PD14-001

2014 Q50; RATTLE NOISE DURING ACCELERATION FROM PROPELLER SHAFT CENTER BEARING

APPLIED VEHICLES: 2014 Q50 (V37) 2WD only

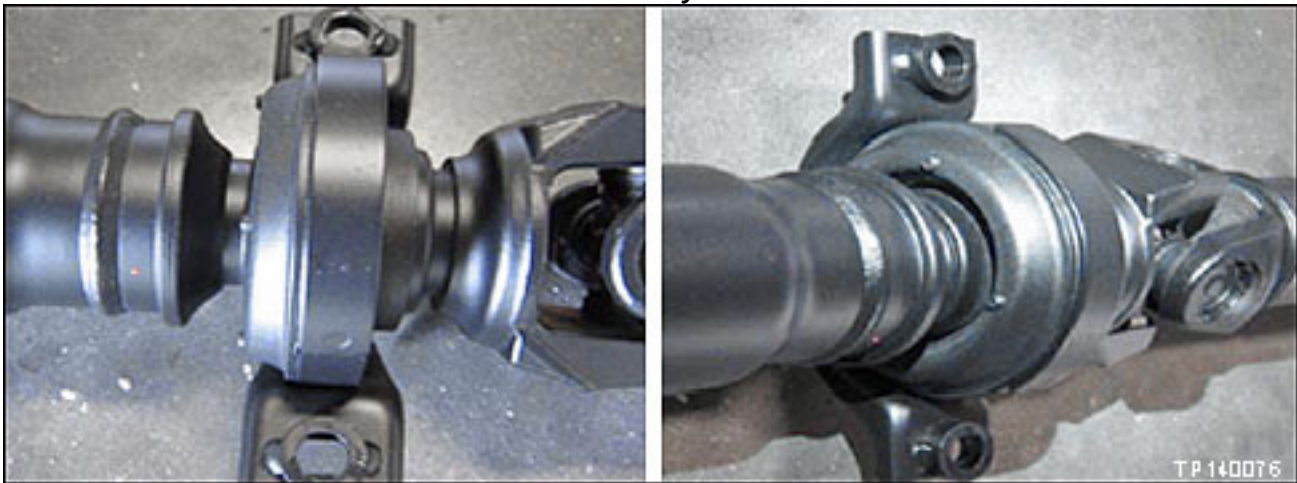
Replace the rear propeller shaft with the new one (new style) listed in the Parts Information.

NOTE: Photos of the “old style” and “new style” rear propeller shafts are on the next page.

DESCRIPTION	PART Number	QUANTITY
Propeller Shaft Assembly (Rear Propeller Shaft)	37000-4GB1A	1
